Report to Development Permit Panel

Re: Application by Matthew Cheng Architect Inc. for a General Compliance Ruling
at 7411 Moffatt Road (formerly 7411 and 7431 Moffatt Road)

DP AMENDMENT RATIONALE

RE: 7411 MOFFATT ROAD
RICHMOND, B.C.

Sheet Title
BUILDING A ELEVATIONS
 (AS BUILT/PROPOSED)

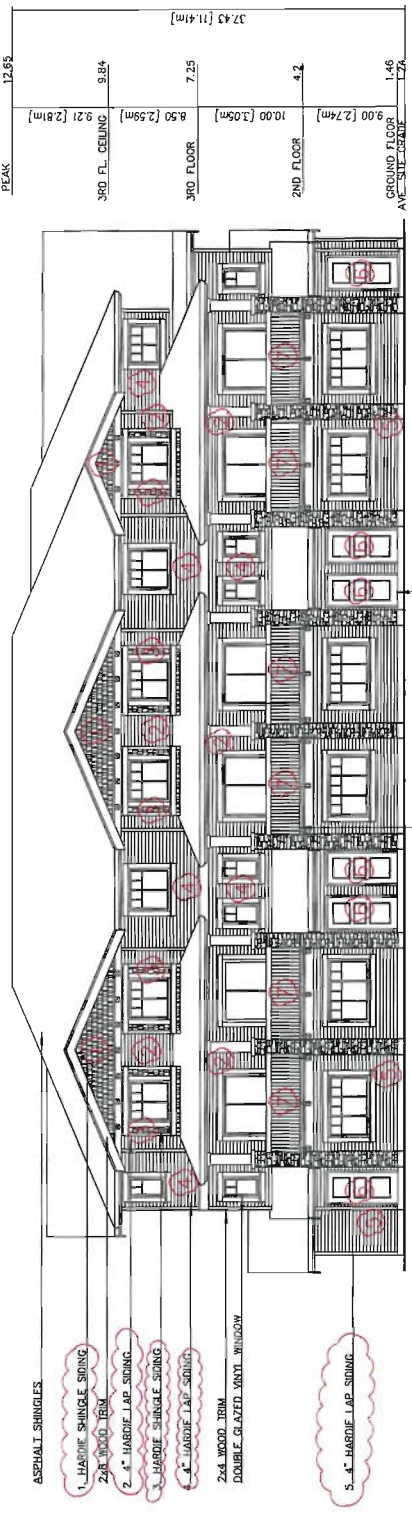
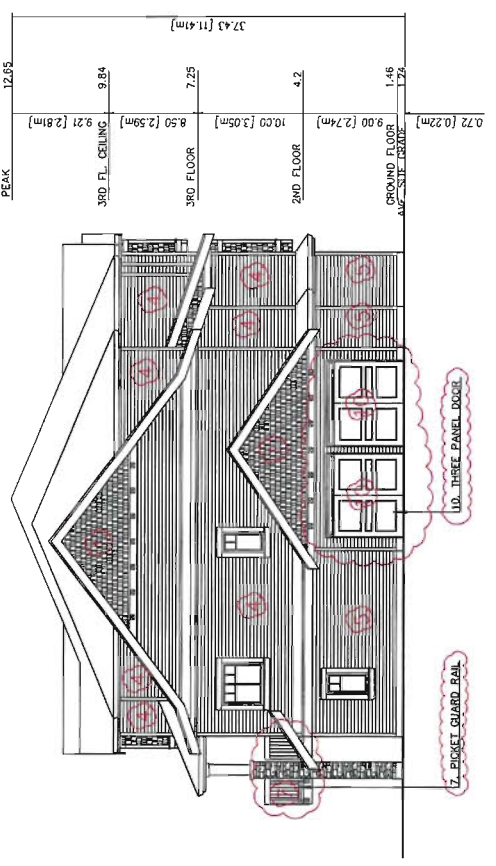
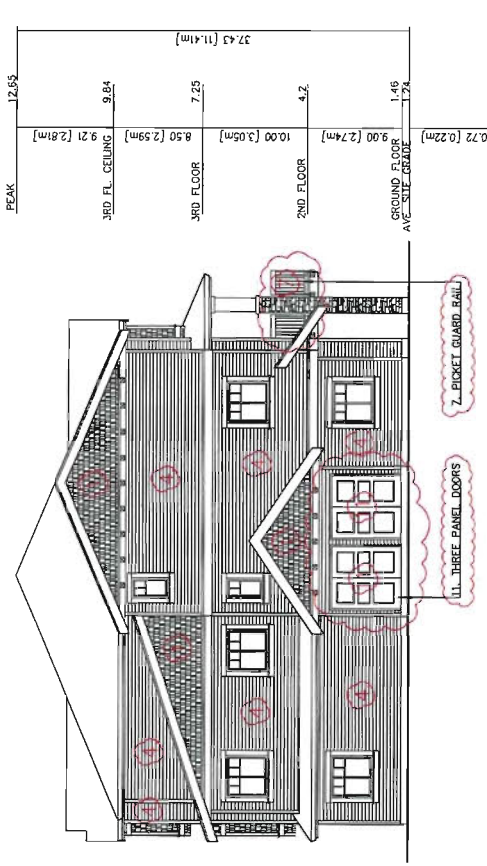
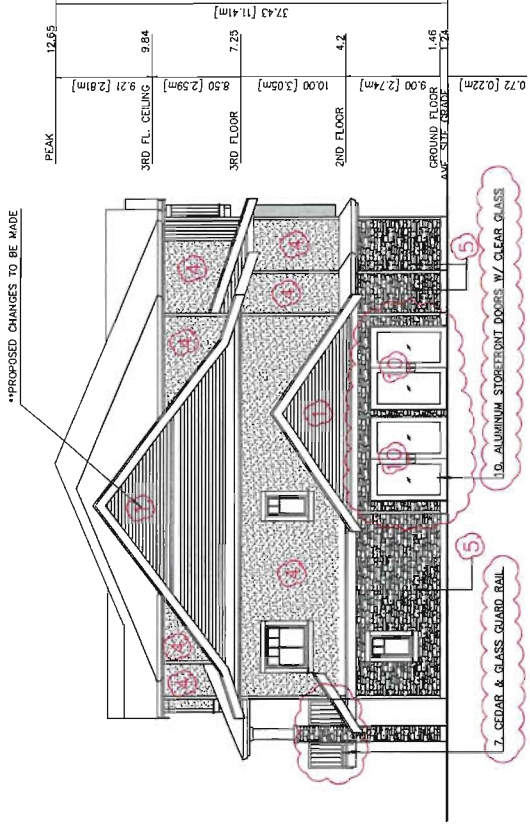
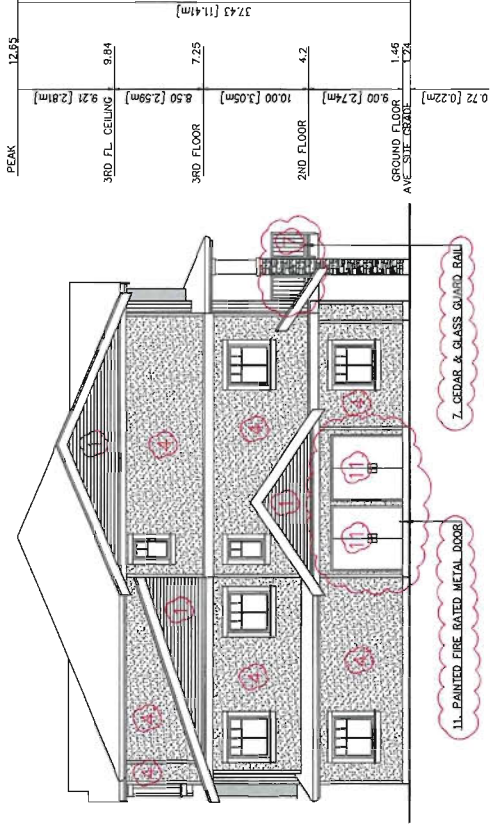
- **Affected Area #1** - The use of Hardie Shingle siding on the gable of the elevations has been upgraded to Hardie lap siding to differentiate from the Hardie board & batten. (See Sheet R01, 4A & 4B – As Built/Proposed)

- **Affected Area #2** - The use of Hardie lap siding on East & West elevations of Building A and B has been upgraded to Hardie board & batten to break up the large volume of Hardie lap siding usage and highlight the verticality of the building. The colour of the Hardie board & batten has been matched to Cedar wood which is used on the guard rail. (See Sheet R01, 4A & 4B – As Built/Proposed)

- **Affected Area #3** - The façade of the units on West & East Elevations of building A and East elevation of building B, has been changed from Hardie shingle siding to Metal Panel to create modern design. (See Sheet R01, 4A & 4B – As Built/Proposed)

- **Affected Area #4** - The use of Hardie lap siding on the elevations has been upgraded to rock dash stucco to break up the large volume of Hardie lap siding usage and also bring more natural material palette to the building. (See Sheet R01, 4A & 4B – As Built/Proposed)

- **Affected Area #5** - The material on the ground level has been upgraded from Hardie lap siding to Cultured Stone to introduce street frontage which wraps around the buildings and highlight the entrances and garage access for the units. The natural material blends in harmony with the context and the landscape around the building. (See Sheet R01, 4A & 4B – As Built/Proposed)

- **Affected Area #6** - The entrance doors on Building A, East elevations (Facing Moffatt Road) and Building B, East elevations have been upgraded from three panel doors to solid cored oak veneer door with wood stain to create more modern and high-end entrance. (See Sheet R01, 4A & 4B – As Built/Proposed)

- **Affected Area #7** - The traditional picket guard rail has been upgraded to Cedar and glass guard rail to embrace local natural materials with sleek modern look of the glass. (See Sheet R01, 4A & 4B – As Built/Proposed)

-
- **Affected Area #8** - The three panel doors on Building A, West elevation have been upgraded to painted fiberglass door to create simple and modern look that fits within the overall design of the development. (See Sheet 4A– As Built/Proposed)

- **Affected Area #10** - On the Building A North elevation, the three panel doors have been upgraded to aluminum storefront door with translucent glass to make garbage and recycle area more accessible. Also by opening up the North Elevation with a translucent glass, it improves the pedestrian experience and makes the entry more inviting. (See Sheet 4A– As Built/Proposed)

- **Affected Area #11** - The three panel doors on Building A, South elevation have been upgraded to solid painted fire rated metal door to create simple and modern look that fits within the design of the development. (See Sheet 4A– As Built/Proposed)

Sheet Title
BUILDING B ELEVATIONS
 (AS BUILT/PROPOSED)

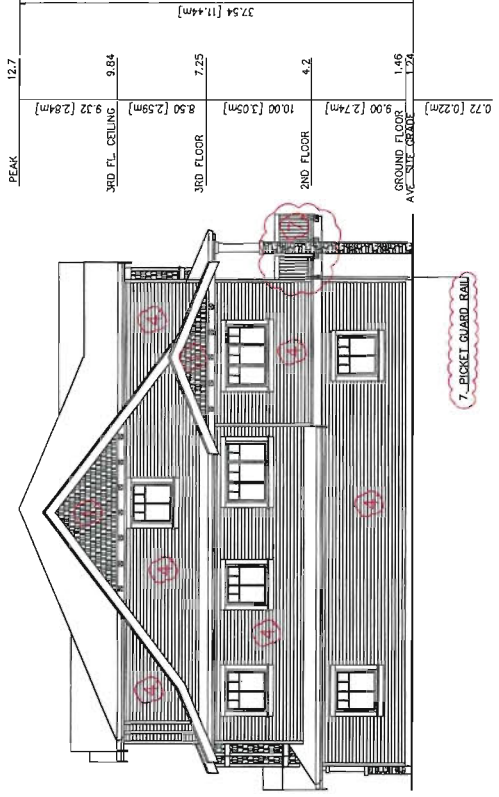
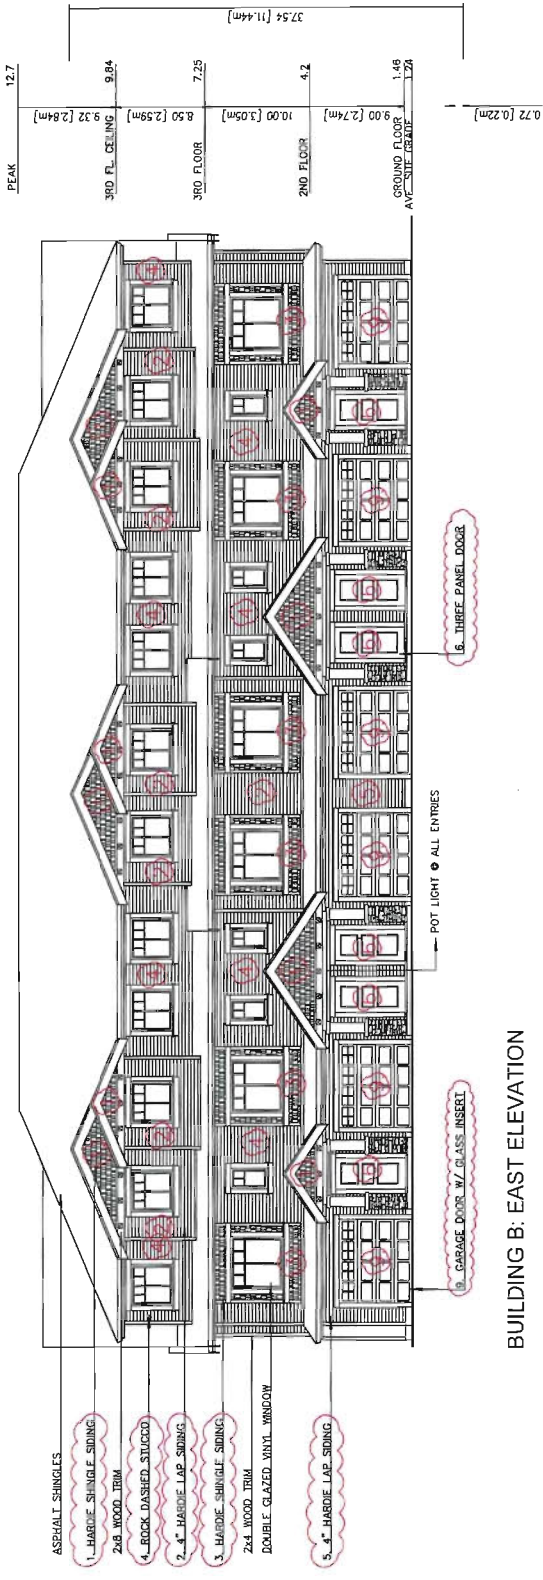
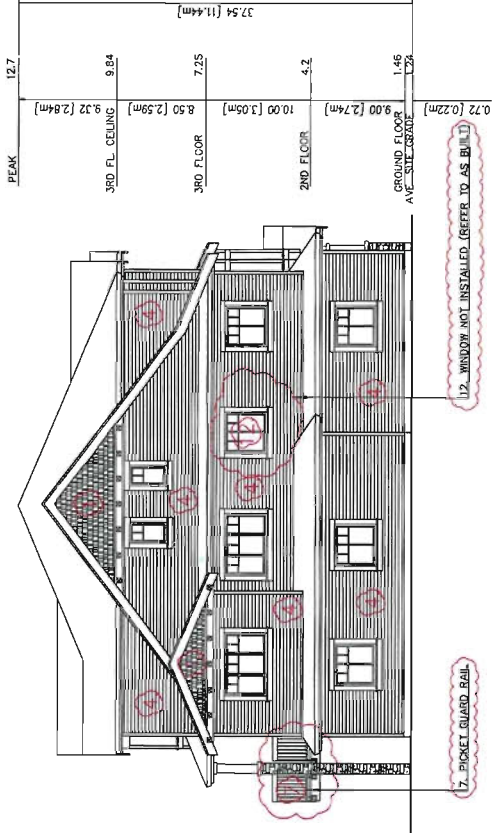
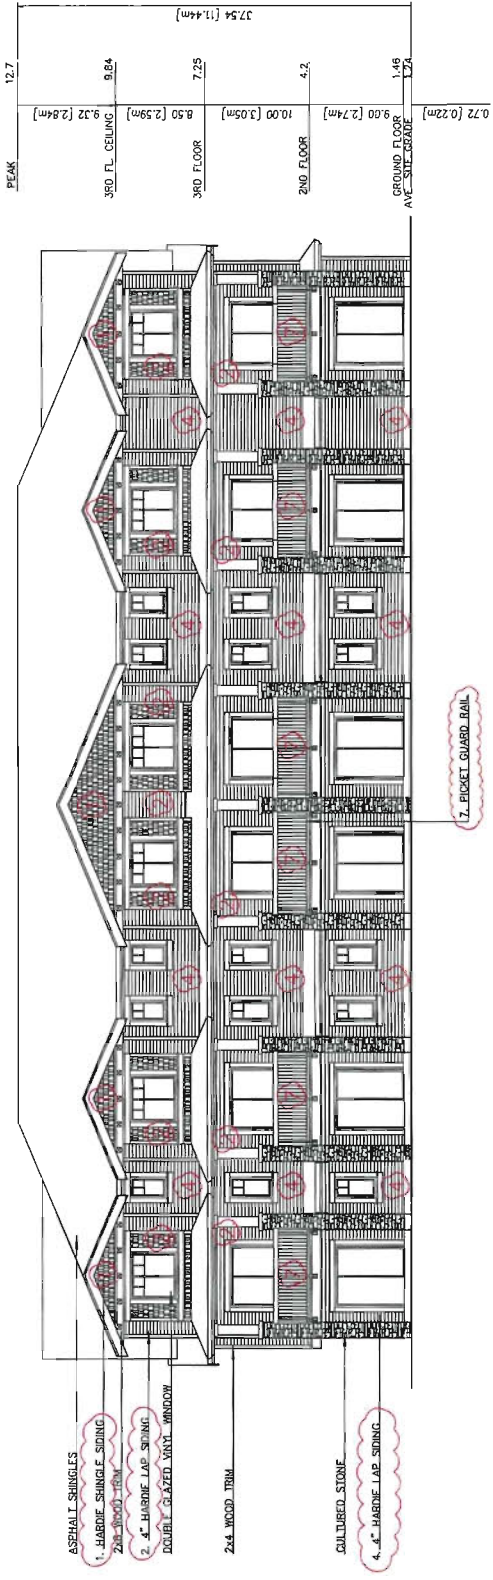
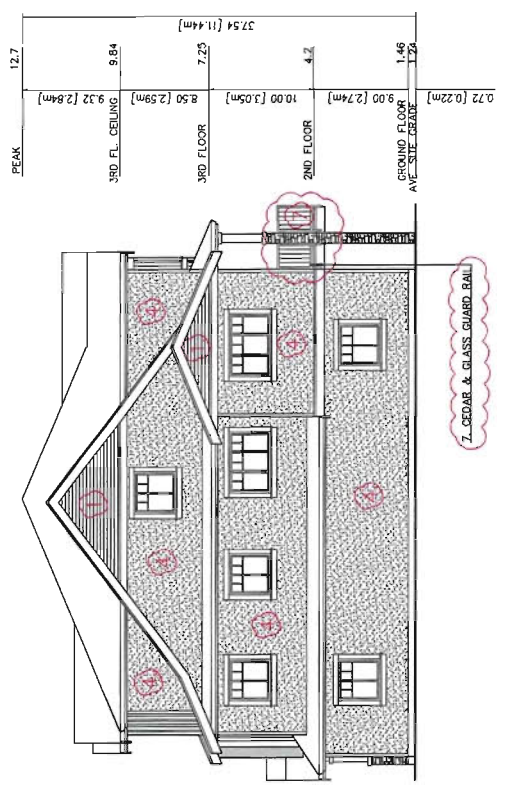
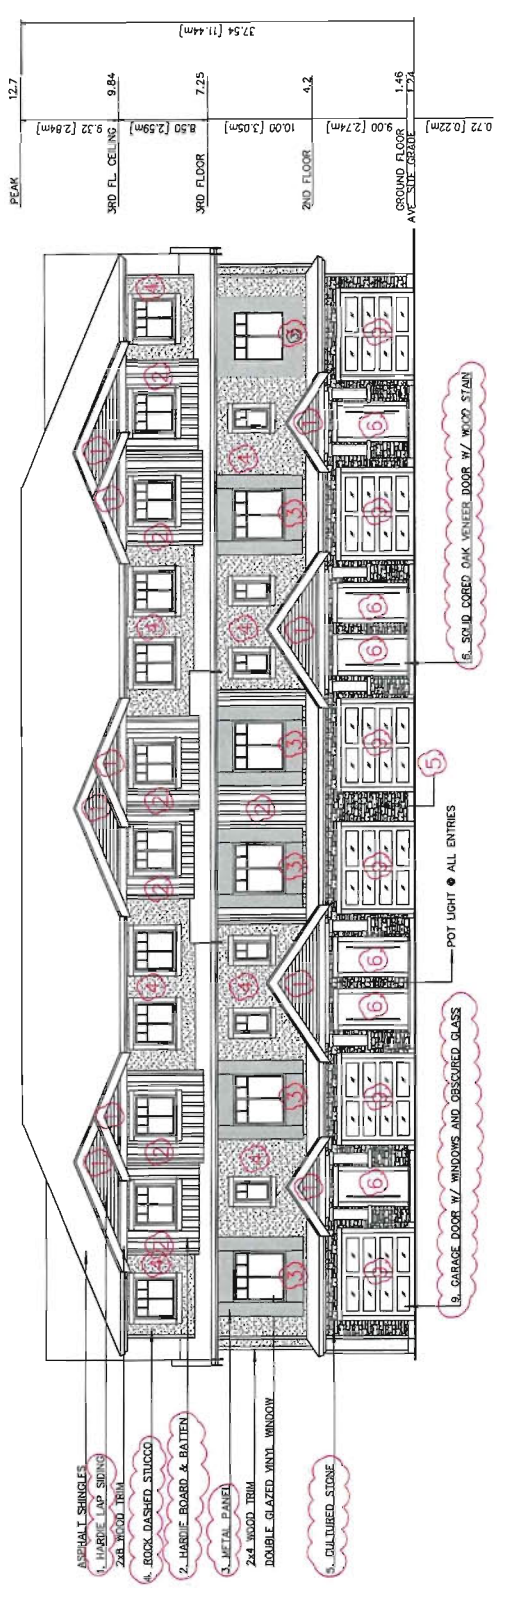
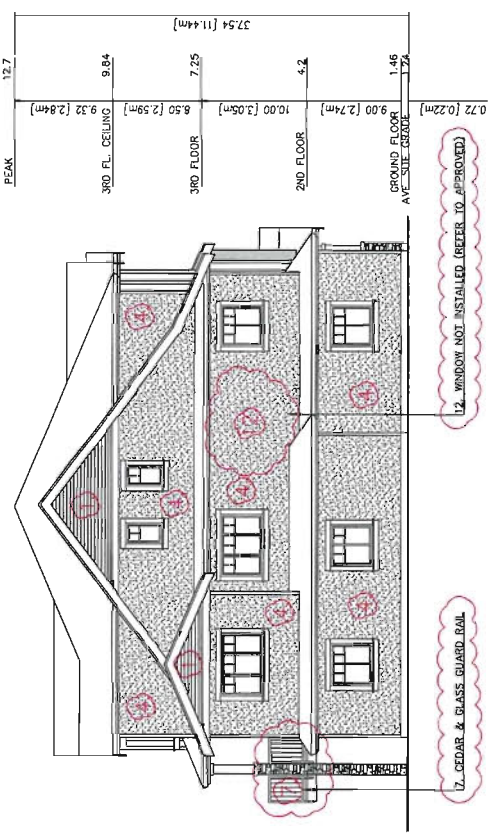
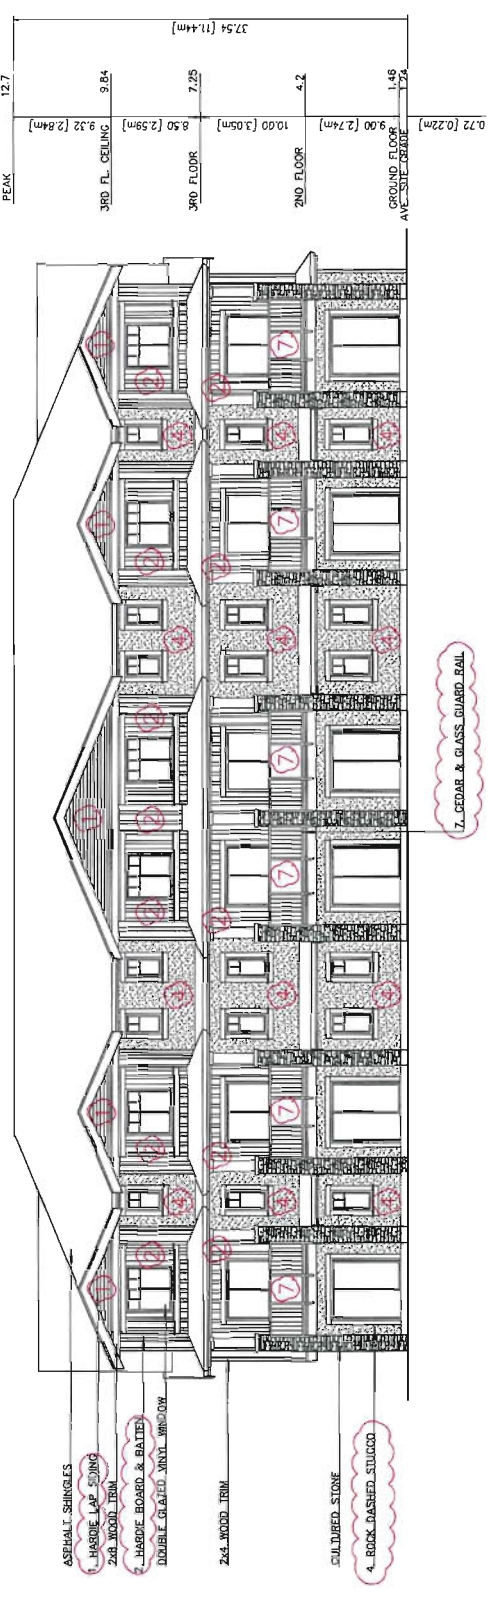
- **Affected Area #9** - The garage door with a glass insert on Building A, West elevation and Building B, West elevation has been upgraded to garage door with windows and obscured glass to bring more natural light into the garage space and making it more transparent from the outside. (See Sheet 4A & 4B – As Built/Proposed)

- **Affected Area #12** - On the South elevation and the second level floor plan of building B, a window is removed due to practicality issue as the location of stovetop is aligned directly with the window and also to avoid condensation issue. (See Sheet 4B & 5B – As Built/Proposed)
